# Transmittal of Drawings

| **CSI Job #** | **C22312** | **Submittal No:**<br><br>**Revision No:** | C22312 - Submittal-002217 - BC/CS-BOX CULVERT W/CS WW |
| **Project:** | VT/DOT Bridge Replacement - Roadway Improvements TH 3 FAS 0302 in RICHFORD, VT | **Project No /**<br>**Contract No(s):**<br>**Federal Aid No(s):** | BRF030229 / |

D | 26' SPAN X 10' RISE 3-SIDED CULVERT | REV 3
Drawing No. C22312-L01A
Quantity: 1 | Project No: BRF030229 | SHEET 1 OF 2

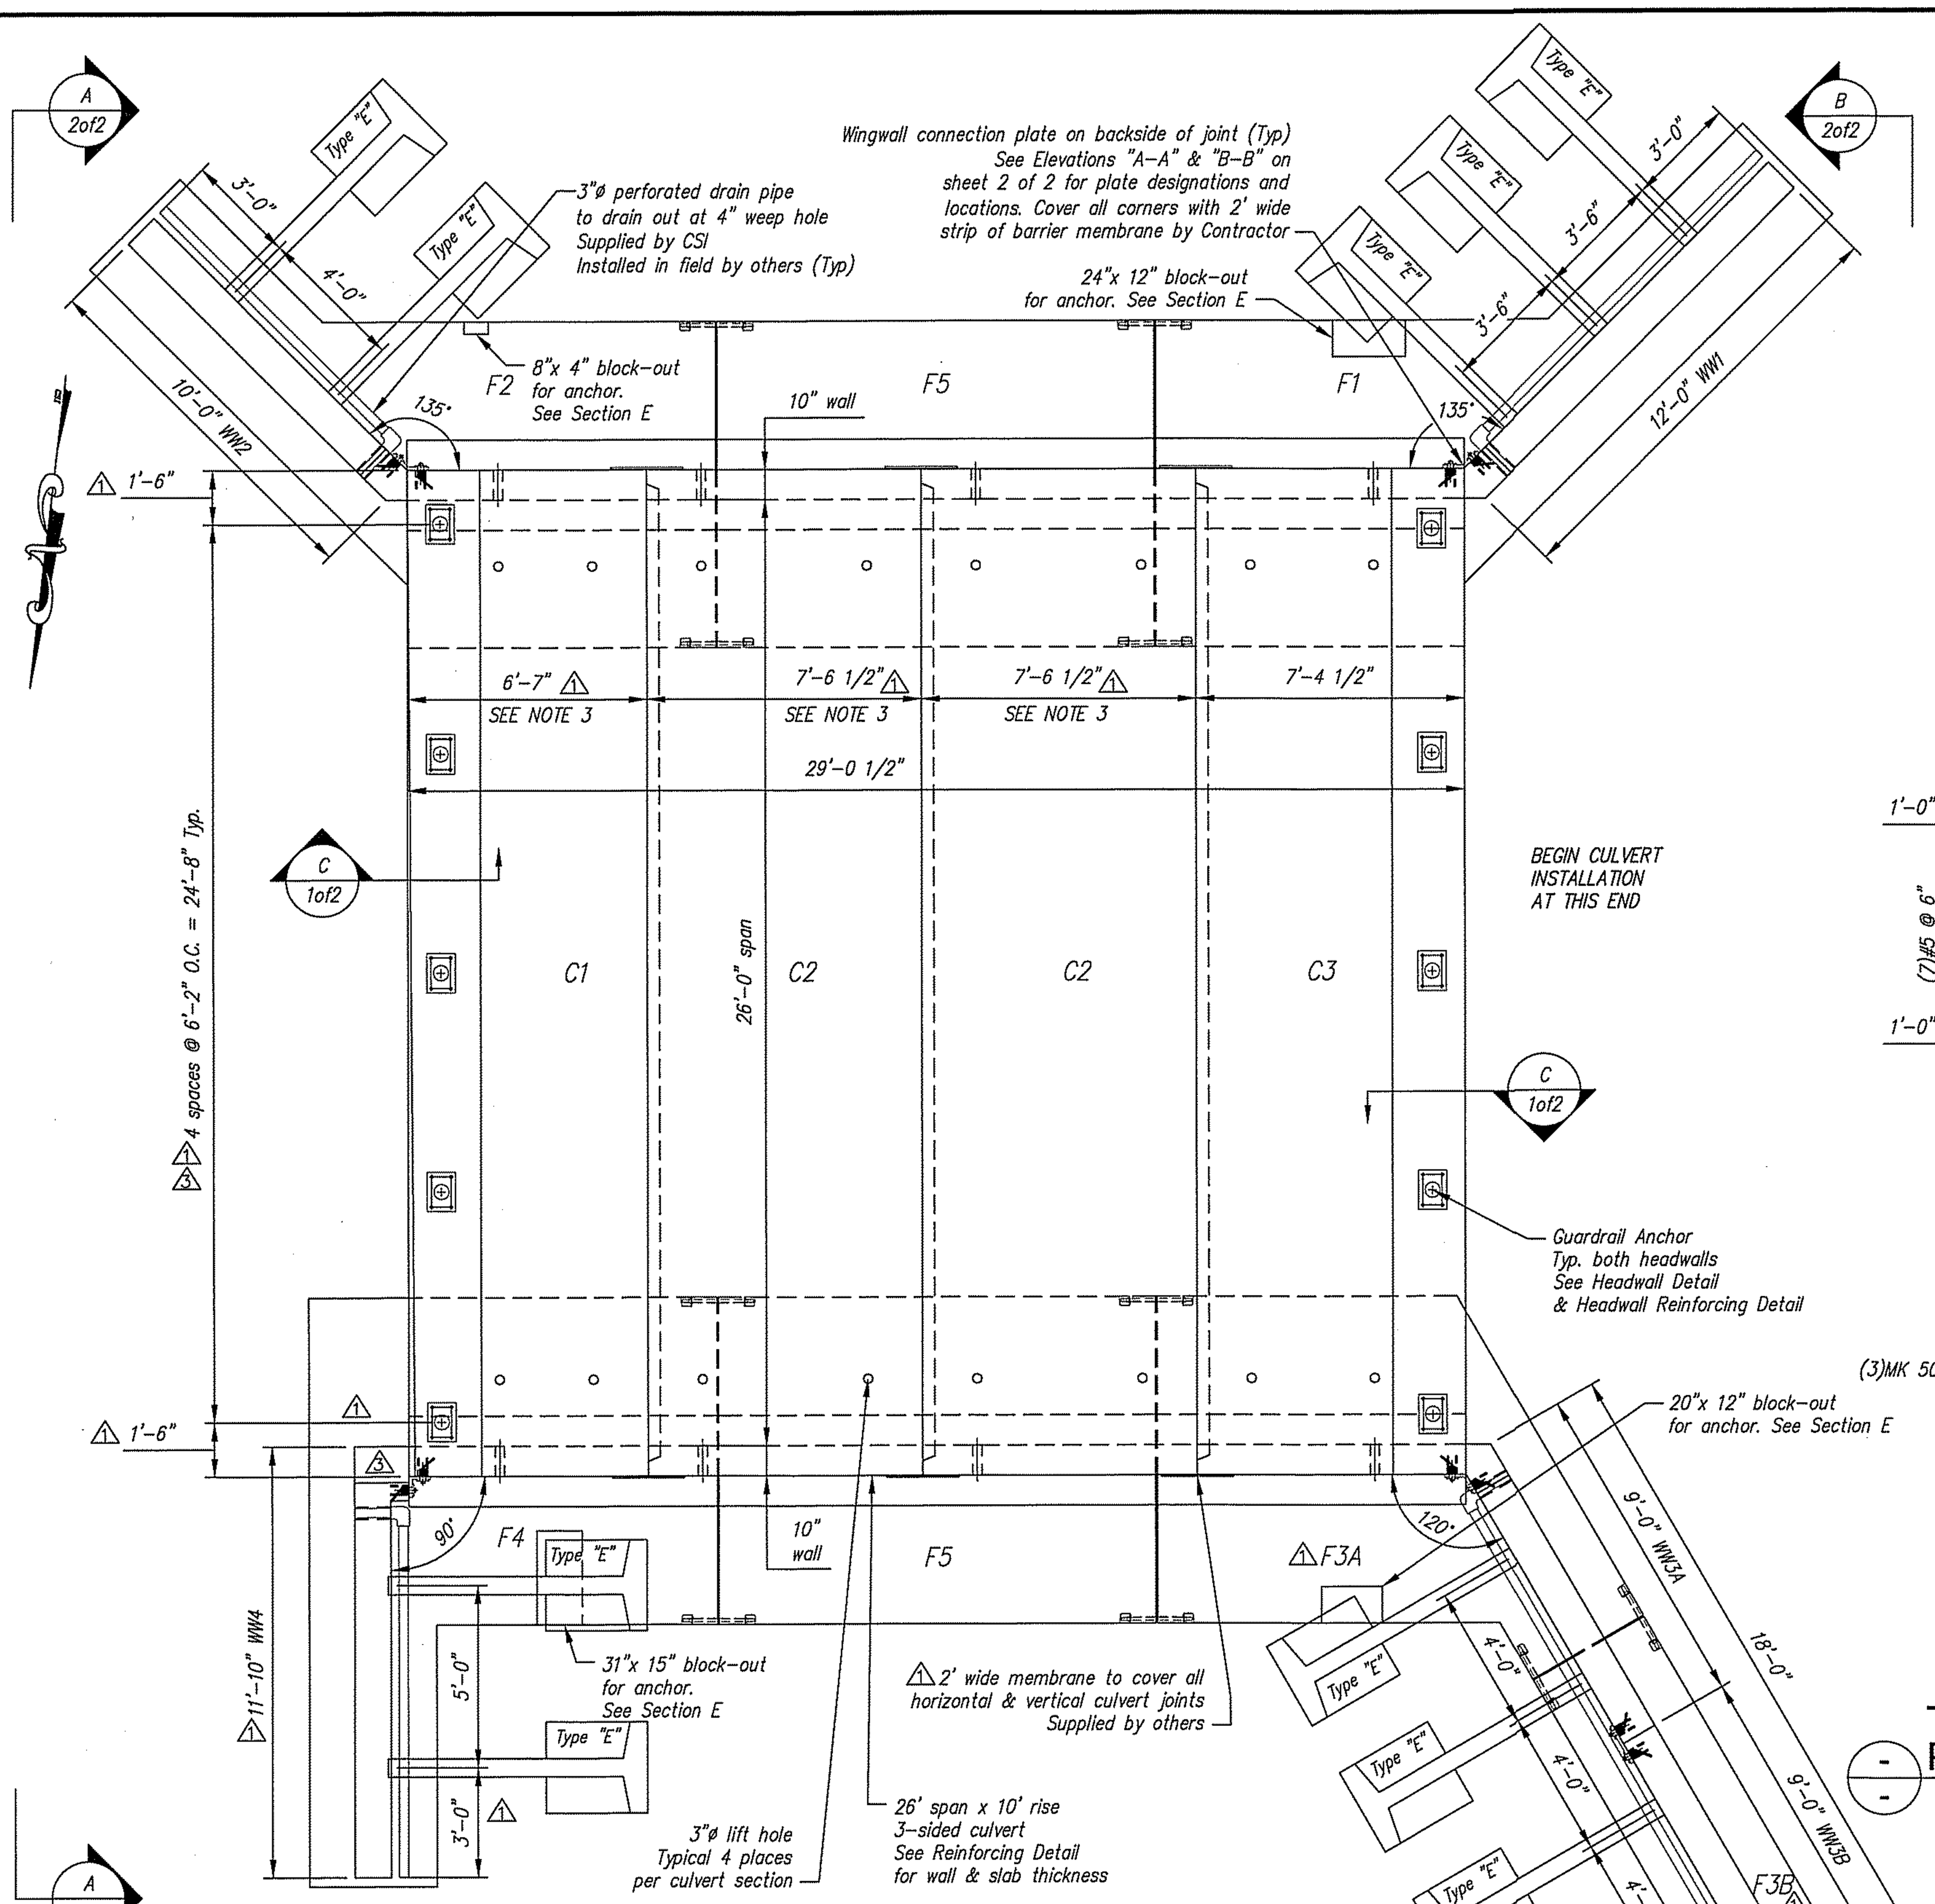
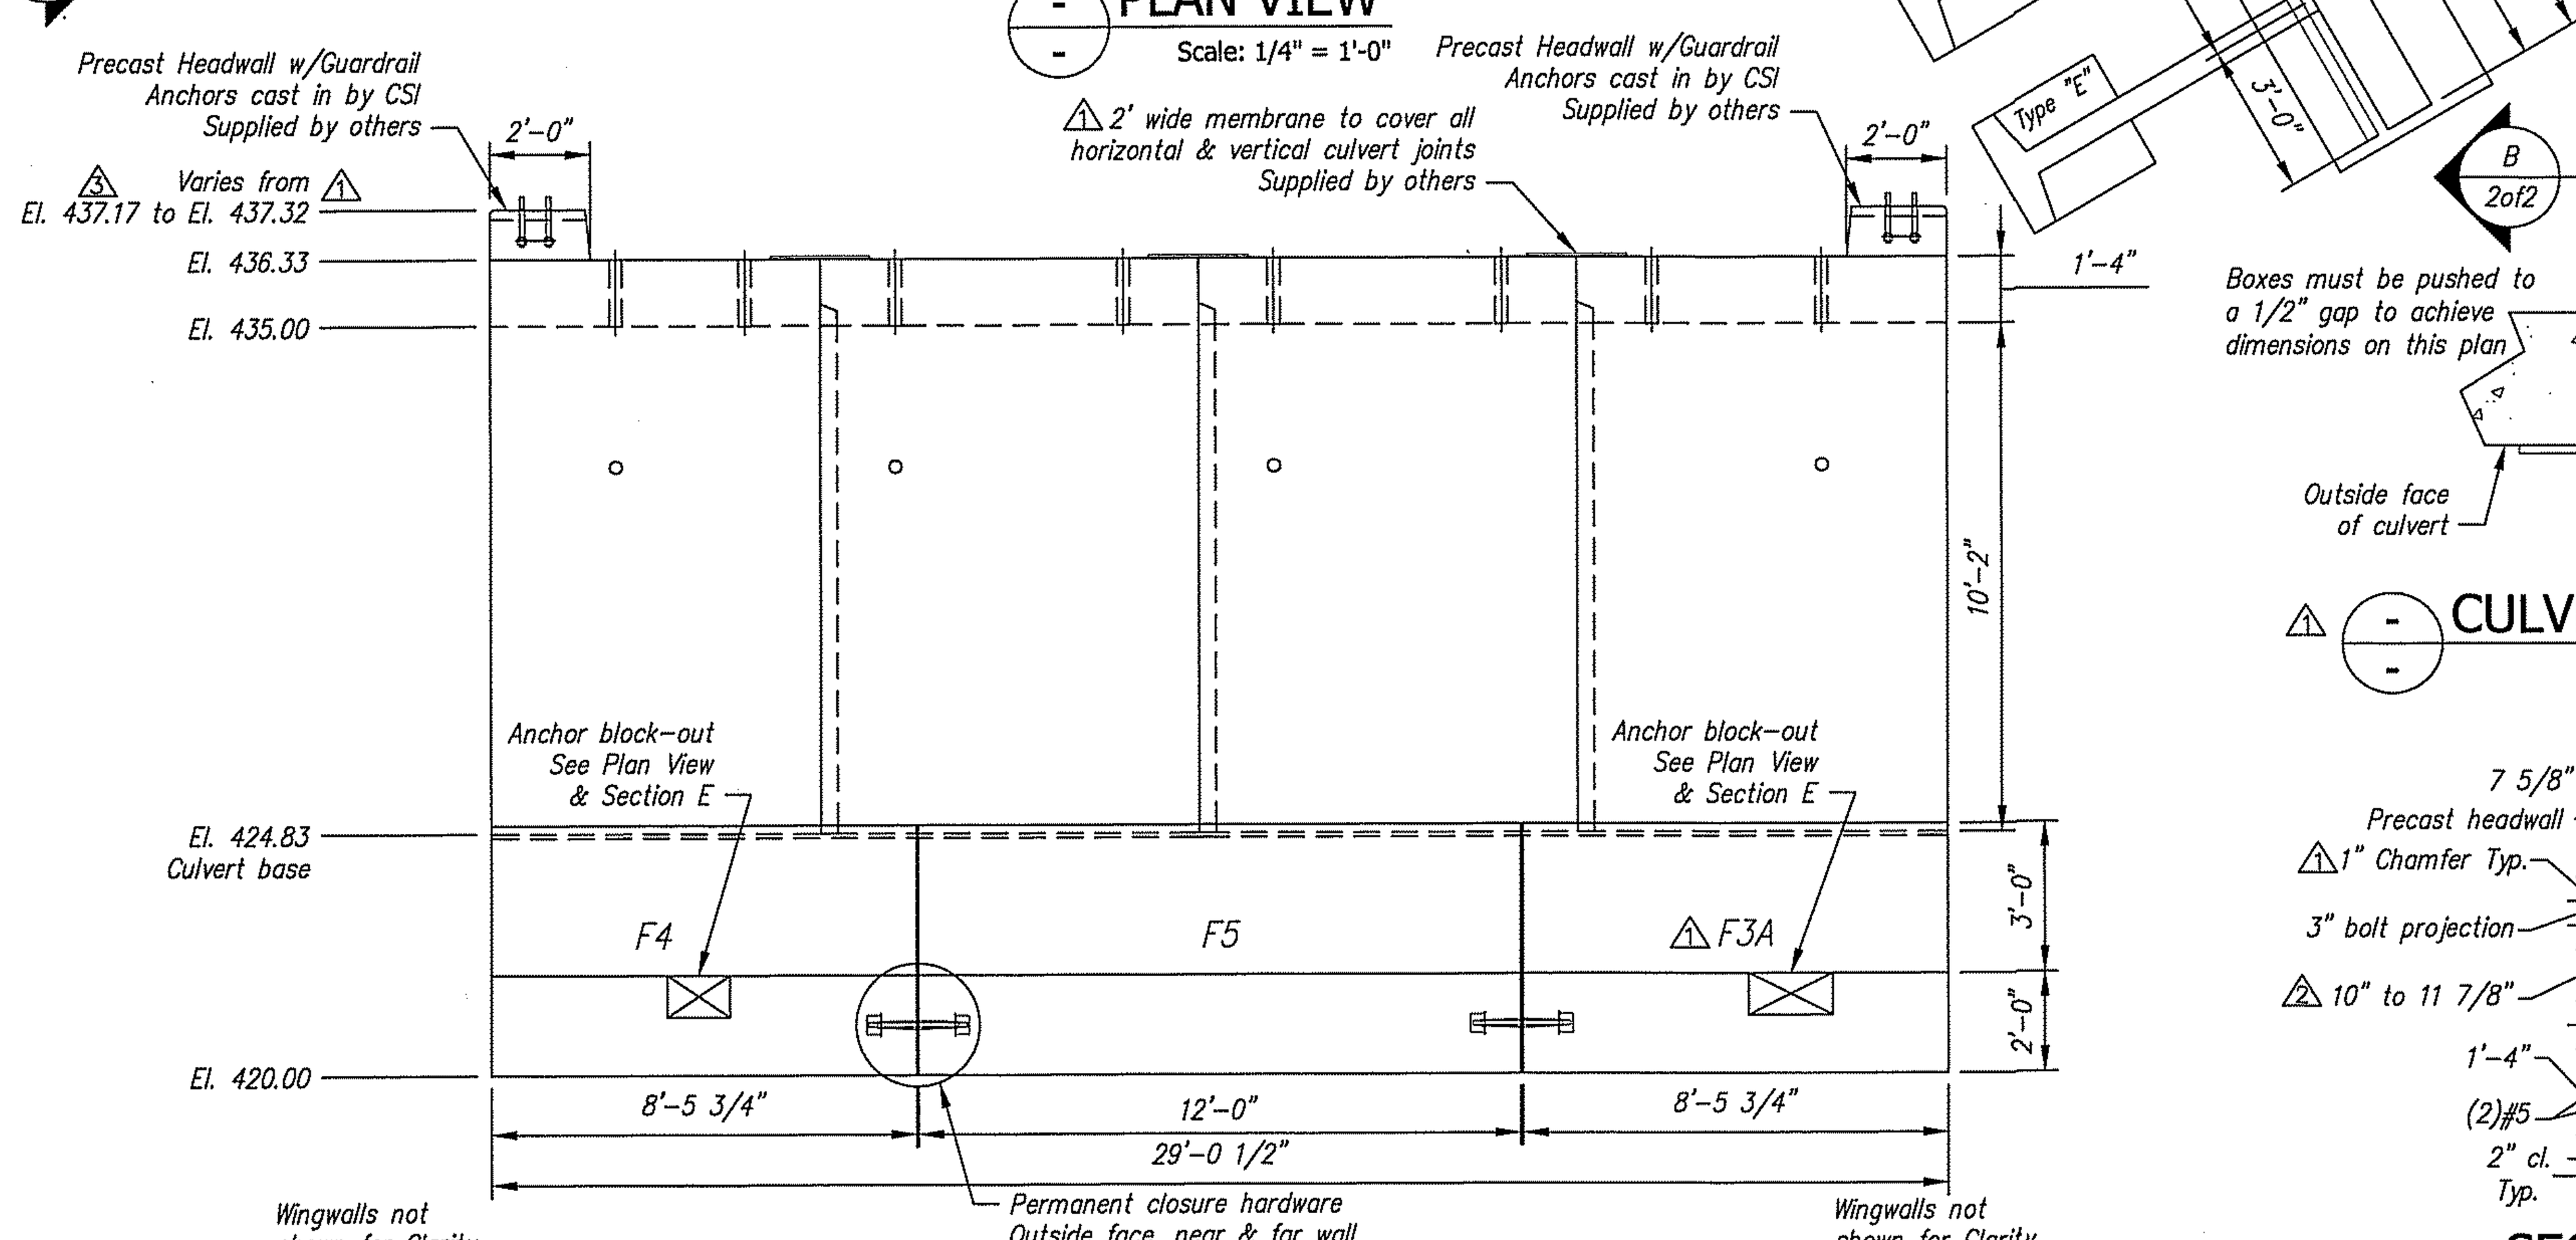
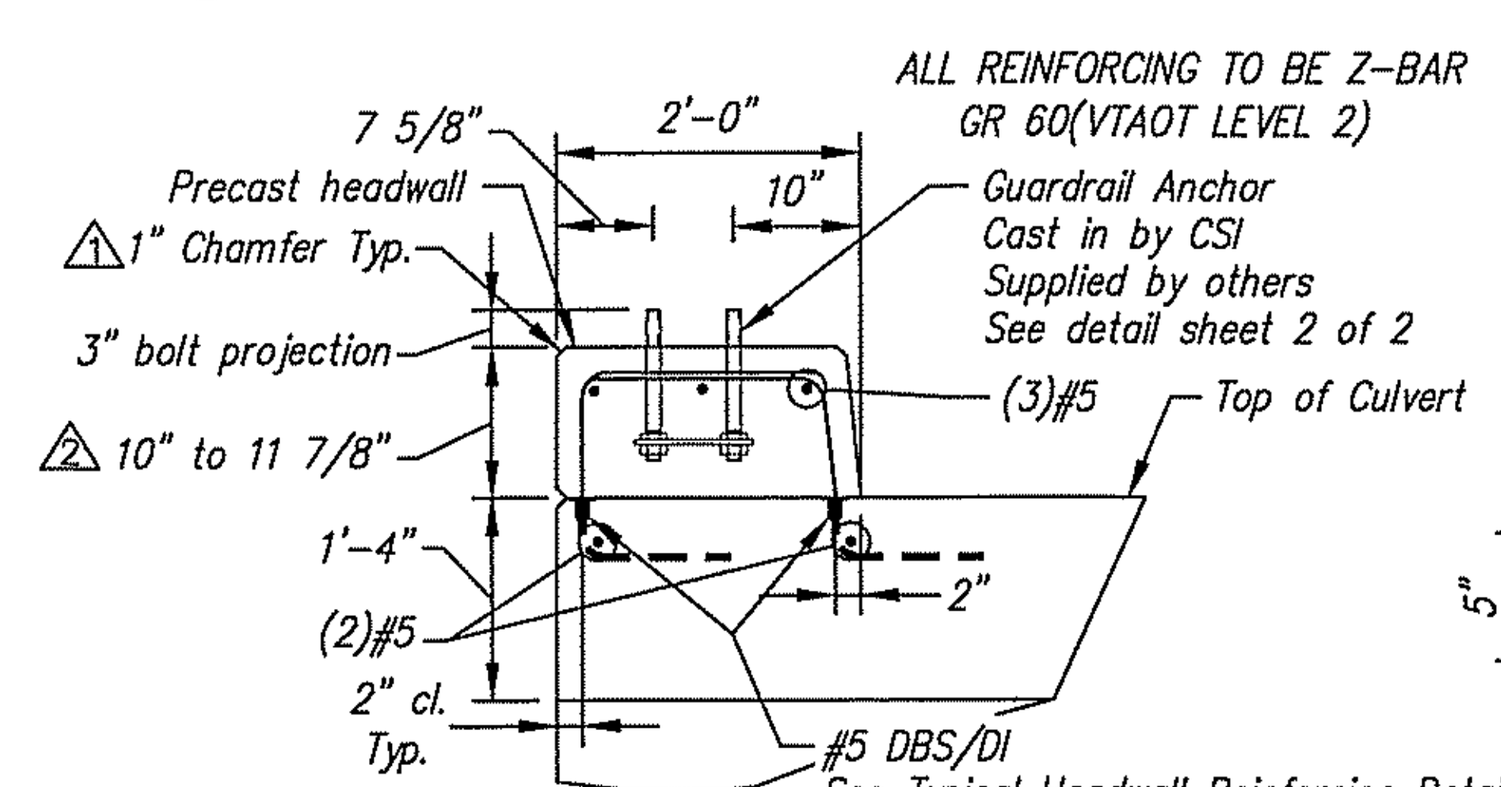
| Rev. | Date | DESCRIPTION | By |
|---|---|---|---|
| 2 | 28MAY2015 | REVISED PER CUSTOMER REVIEW, SECTION C-10" DIM WAS 9 1/2", EXTENDED WINGWALLS EVEN WITH HDWALL | RY |
| 1 | 14MAY2015 | REVISED PER CUSTOMER REVIEW, MOVED WW4, ADDED F3A & F3B, REVISED GUARDRAIL ANCHORS | RY |
